To: T10 Technical Committee
 From: Luben Tuikov, Vitesse Semiconductor (ltuikov@vitesse.com)
 Date: 19 October 2006
 Subject: 06-460r1 SAM-4 Time bounds of task states

Suggested changes

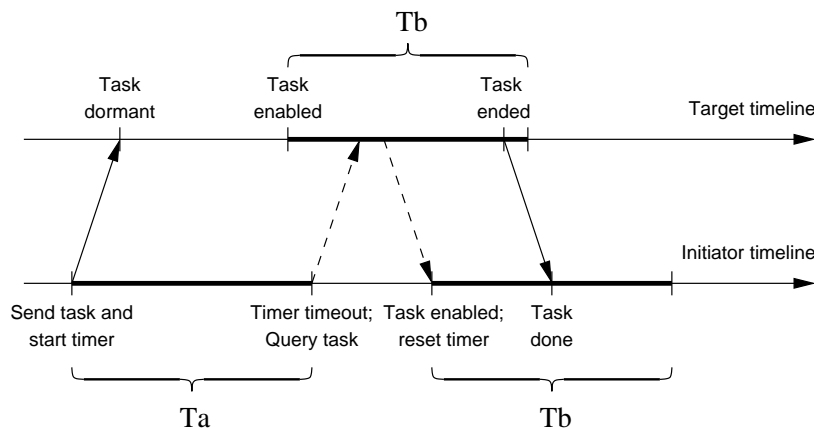
The suggested changes are that the timeout value specify time spent in the TASK ENABLED and TASK ENDED task state. This of course implies that TASK ENABLED and TASK ENDED state is bounded in time. This is not a problem since the time bounds are not specified in the Architecture. As far as the Architecture is concerned a time bound of 100 million years is just as good as 100 microseconds, for example.
